**SECTION 00 91 13.01**  
**ADDENDA #01**

- A. Project Name: Royal C. Johnson Veterans Memorial Medical Center New Front Lobby & Primary Care Addition.
- B. Owner: U.S. Department of Veterans Affairs.
- C. Owner Project Number: 438-480
- D. Architect: Stone Group Architects.
- E. Architect Project Number: 201909.
- F. Date of Addendum: February 13, 2024.

**E1B WALL SECTION AT CONNECTION TO EXISTING A**  
1/2" = 1'-0"

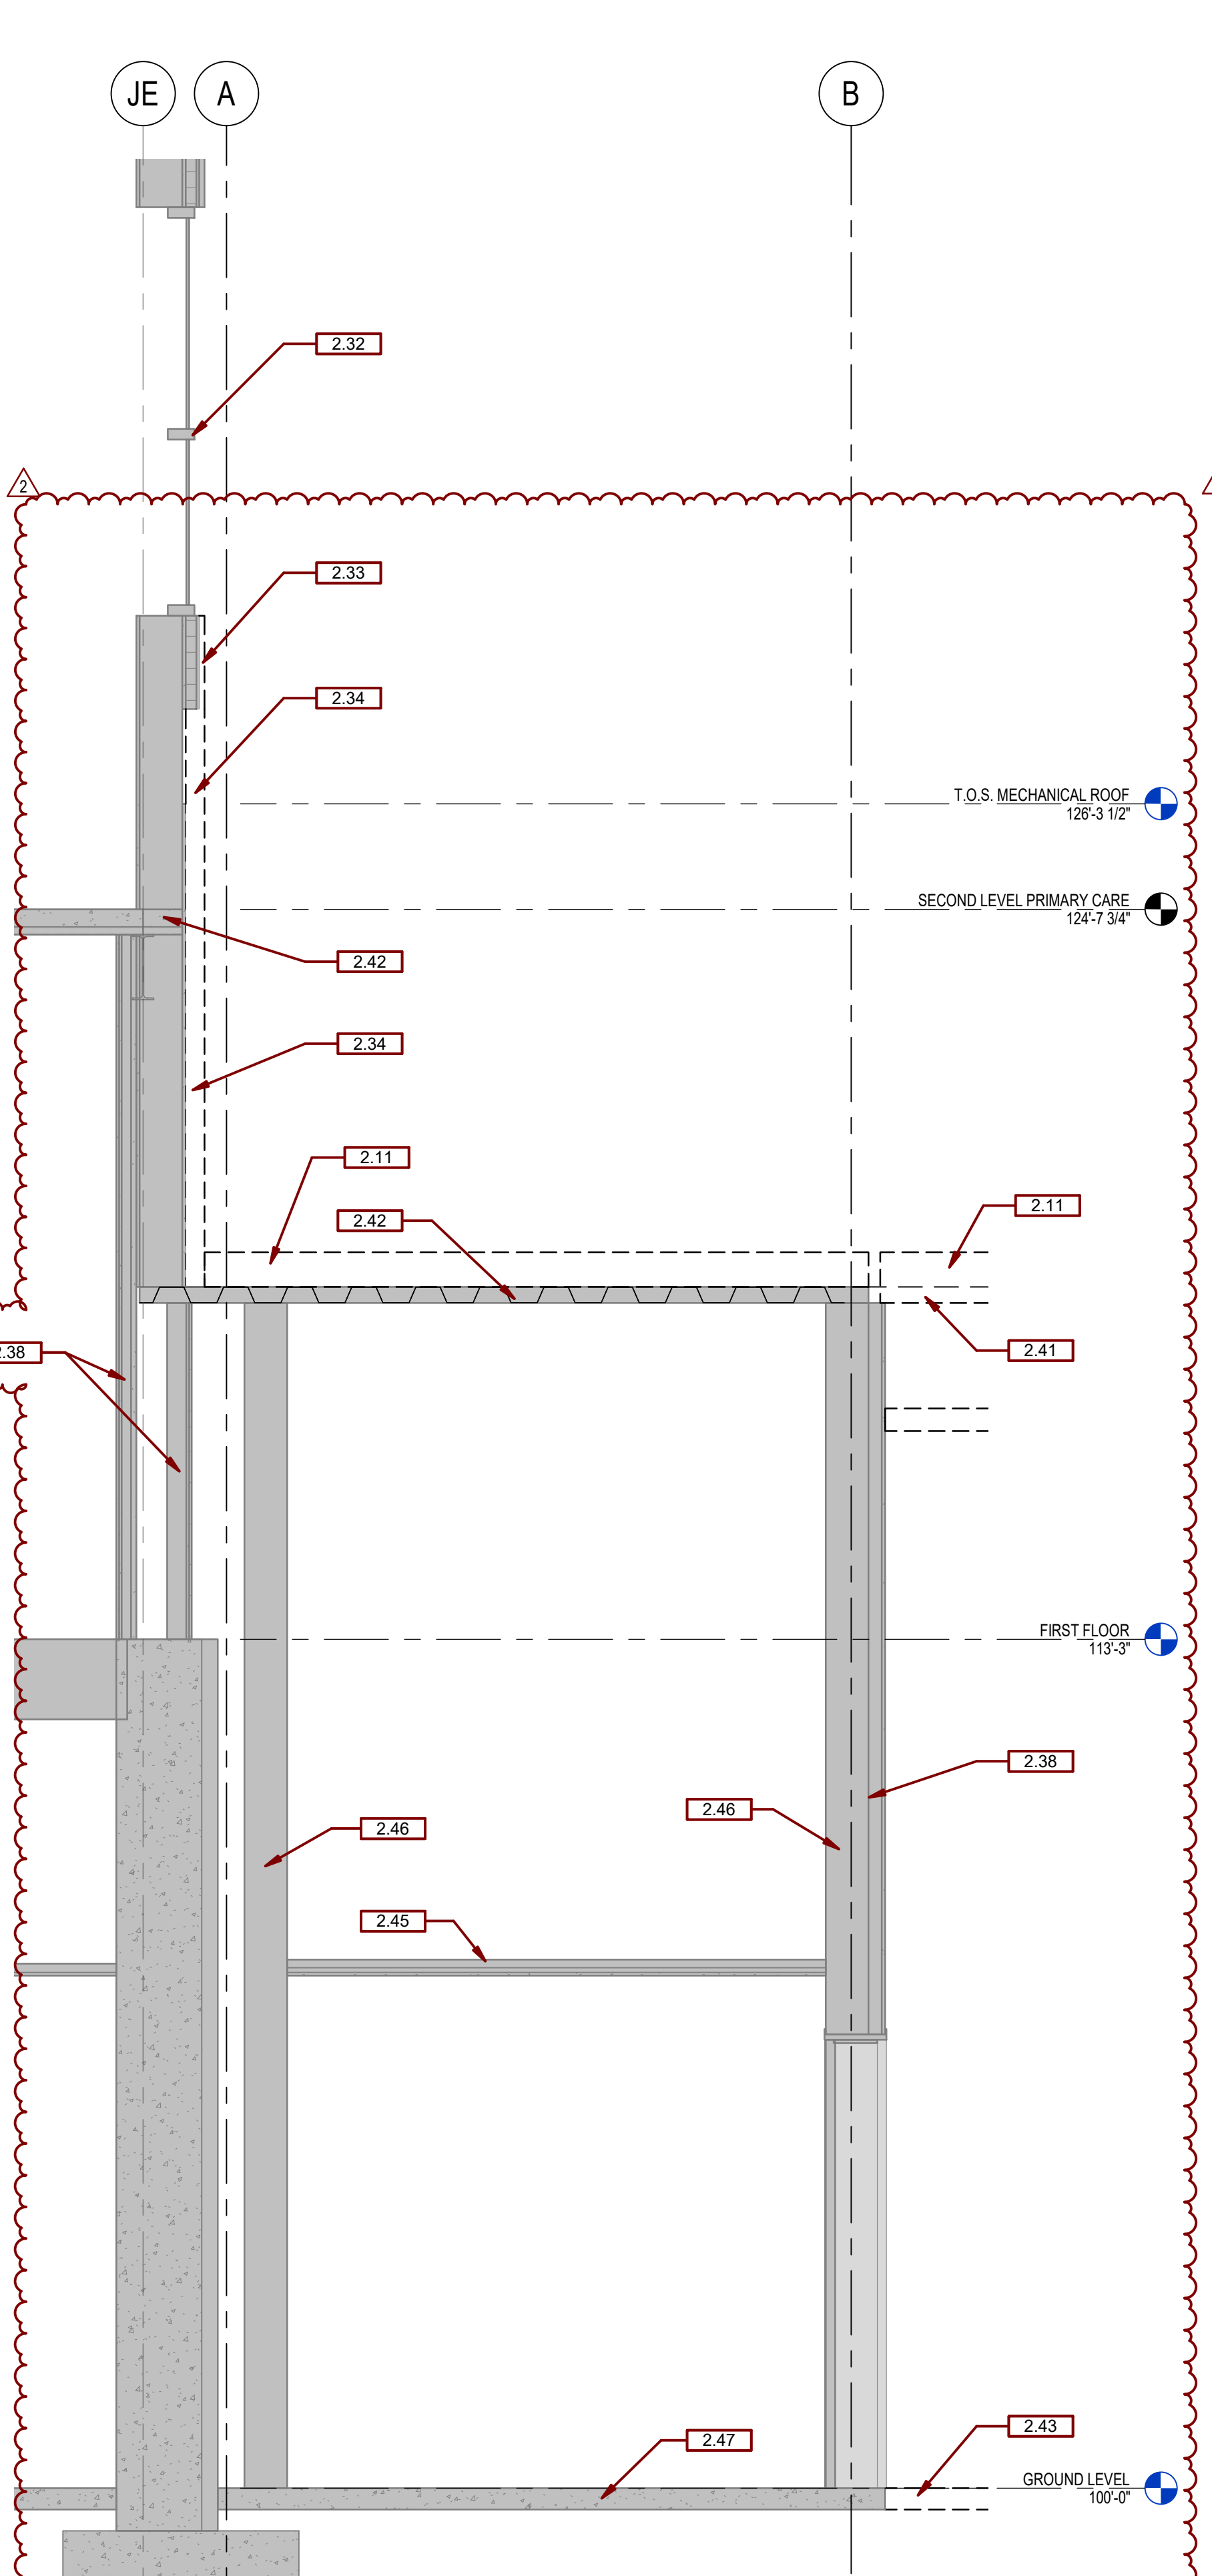
- O. Sheet AE314 - WALL SECTIONS (reissued).
  - 1. Section E1A - Added keynote for existing concrete wall to remain.
  - 2. Section E1B - Added clarification to new floor slab and removed insulation hatch in shaft wall assembly.
  - 3. Section E2A - Added keynote for existing beams to be removed.
  - 4. Section E2B - Removed insulation hatch in shaft wall assembly.
  - 5. Keynotes - Revised keynote 2.35.
